Client  
**Bradshaw Apartments**  
 Site Address  
 Proposed Multiple Dwellings at Lot 945  
 (#12) Northwood Way, Kallaroo

Council is required to determine whether the proposed development of seven multiple dwellings at Lot 945 (12) Northwood Way, Kallaroo is appropriate.

**That Council REFUSES under clause 68 of the *Planning and Development (Local Planning Schemes) Regulations 2015*, the application for development approval, dated 21 April 2020 submitted by Mark Anthony Design for the proposed seven multiple dwellings at Lot 945 (12) Northwood Way, Kallaroo based on the following reasons:**

**ATTACHMENT 1:**  
Assessment Sheet

Figure 3 - Extract of Figure 3.3b of SPP7.3 Vol 2

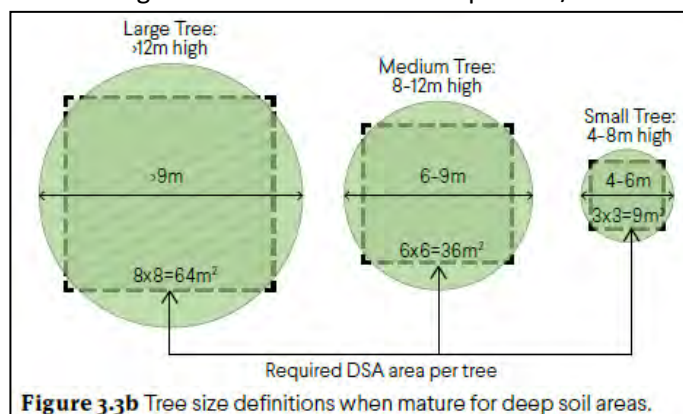
In this instance, three Tree DSA areas are proposed on the north-west and north-eastern portions of the subject site being 7.6sqm, 19.8sqm and 26.4sqm in area. The acceptable outcome criteria require atleast 1 large tree (64sqm) to be provided. As such, the proposal falls notably short. The proposed areas are also inadequate to satisfy the area

required for medium trees as well. As noted above under cl. 2.4 and as illustrated in Figure 1, reduced setbacks further restrict the growth of tree canopies with inevitable clashing with the building structure unless trees are pruned / cut back.
